April 13, 2022

**RE: Green Ridge Recycling and Disposal Facility, LLC
Supplement to Response TR-1 (October 1, 2021)
Notice of Intent and Part A Application - SWP 626
DAA Job Number: 18020117-090102**

Listed below are DEQ comments #11, #14, #15, and #16 (in italics), followed by our corresponding response.

SECTION D-D' - Scale: H: 1"=300', V: 10:1

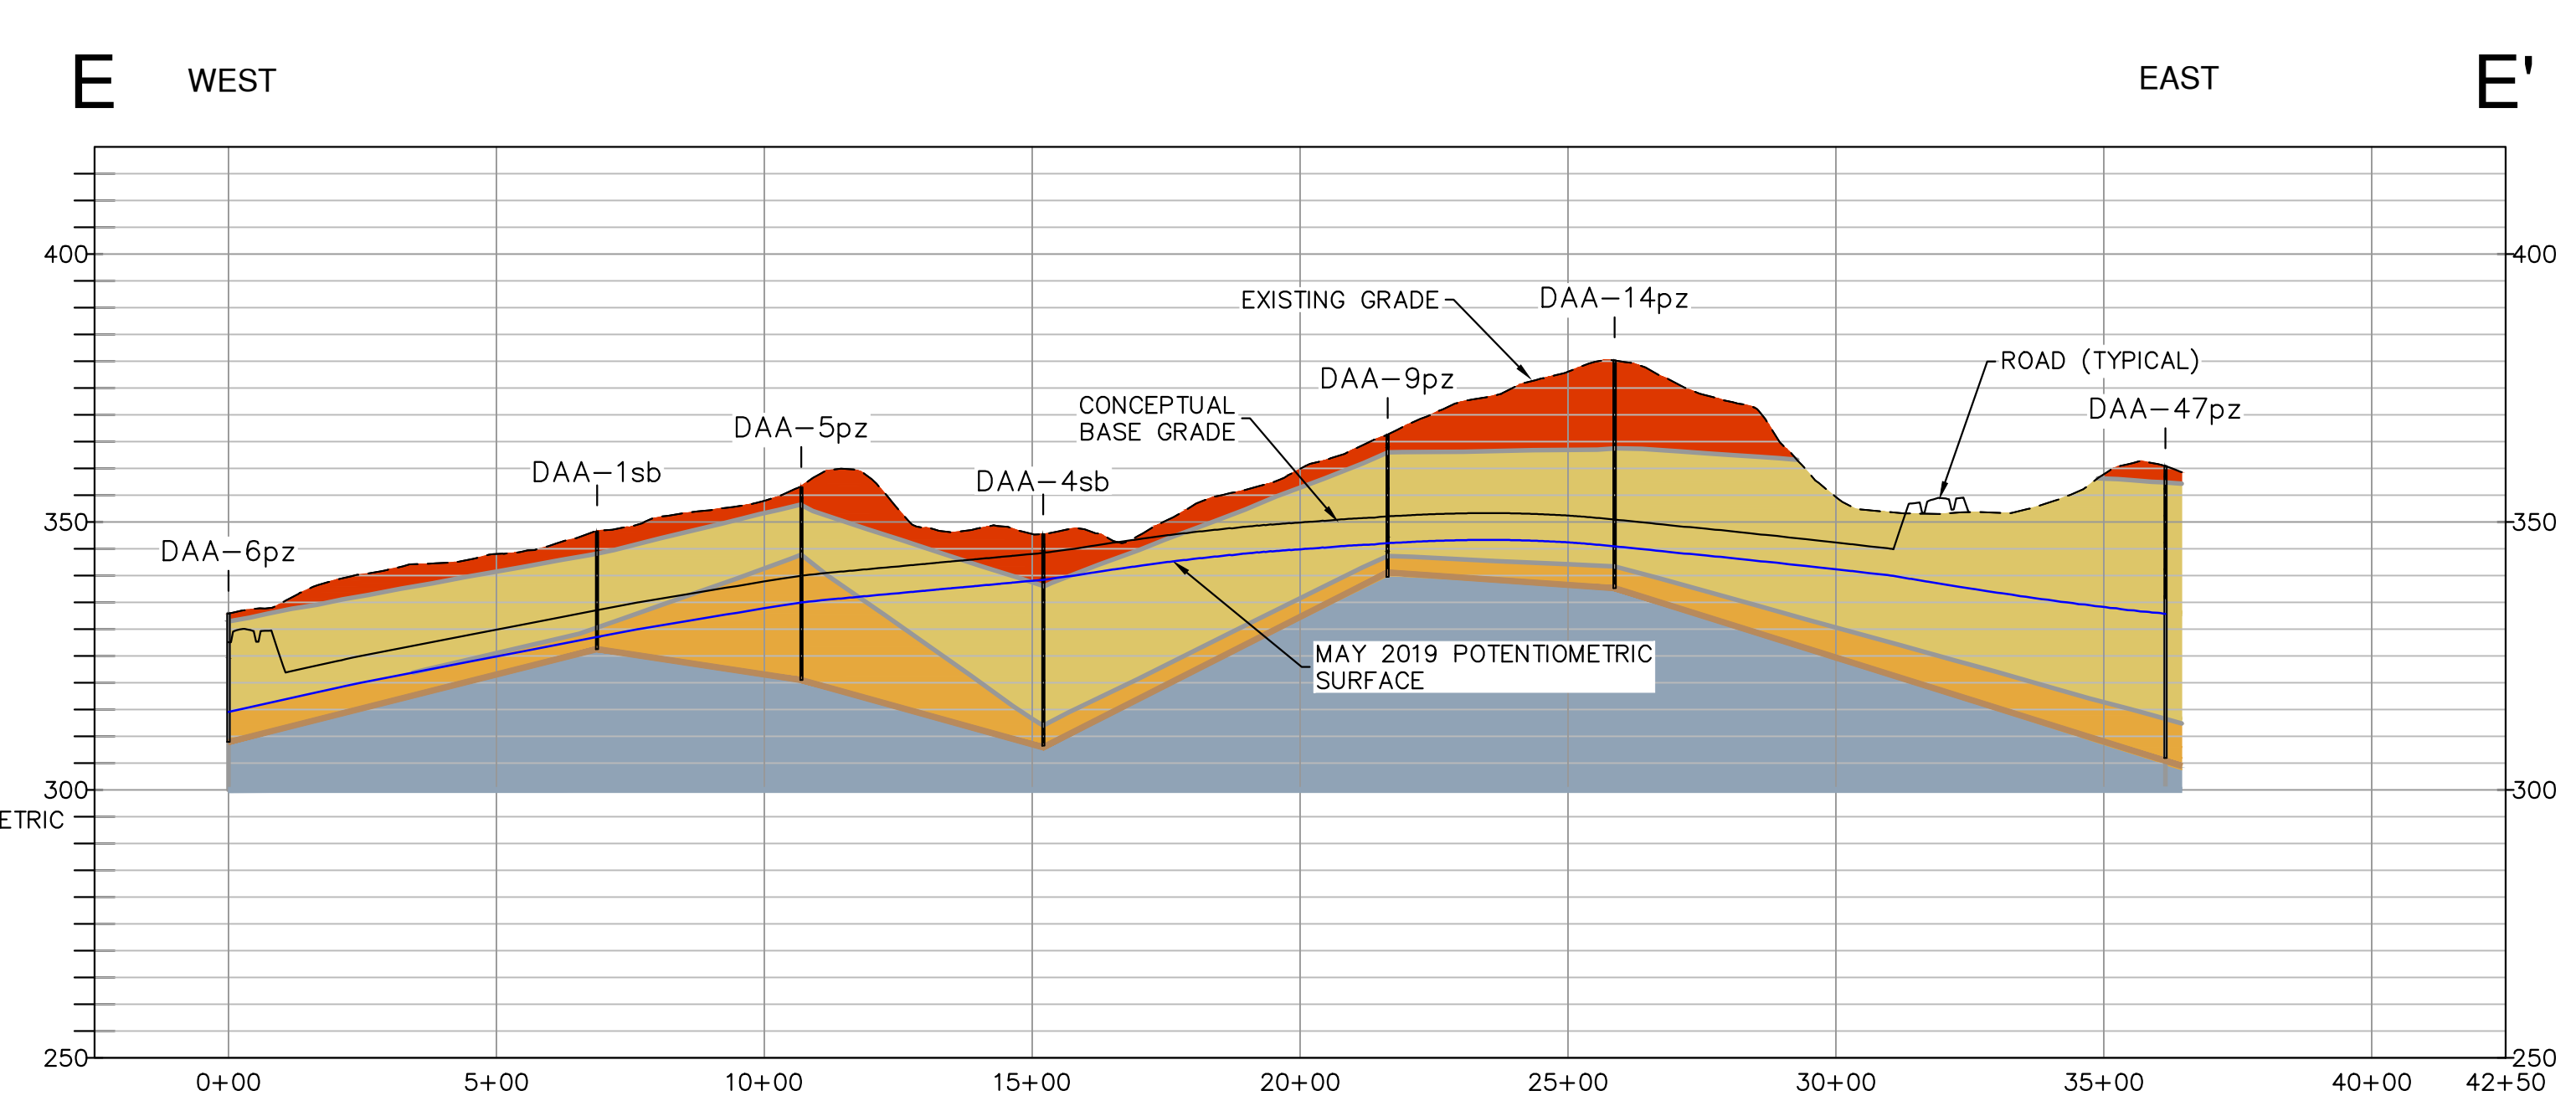
DEQ Comment #11: *The proposed base grades depicted in Attachment XV of the Part A Permit Application show the base grades constructed 10 to 25 feet into the bedrock in some areas (e.g., South of B-5, and near DAA-27sb). However, it appears that none of the borings performed for the Part A Permit Application were installed more than 10 feet into bedrock at the site. In accordance with 9 VAC 20-81-460.E.1.e., at least one deep boring should be installed into bedrock where the deepest base grades are proposed. The bedrock should be cored continuously for the first 20 feet below the proposed base grade. This will provide necessary information in accordance with 9 VAC 20-81-120.D.1 regarding the rate and direction of groundwater flow in the bedrock, ability to monitor groundwater in bedrock, the need for blasting or adjustment of base grades, potential hydraulic inter-connection with other regional groundwater wells, etc.*

Attachment 6 contains a drawing entitled PTA ATTACHMENT XV - FIGURE: CROSS-1 - Revision 1 - "Revised Cross Sections B, D, E, and F," dated 04/12/2022, prepared by Draper Aden Associates and includes updated cross-sections D-D' and F-F', which transect the northern section of the disposal cell. *This figure replaces FIG LA-11 submitted with our October 1, 2021 response.*

Cross-section F-F' has been updated to include the information from deep boring/piezometer DAA-101pz, including the most recent groundwater elevation. Additionally, cross-sections D-D' and F-F' have been updated to show the currently proposed base grades, which were raised to approximately 5 feet above the groundwater elevations in this area. DAA will continue to collect groundwater elevation data at the facility so that final design base grade elevations are a minimum of five feet above the seasonal high groundwater table, as determined by the measurements.
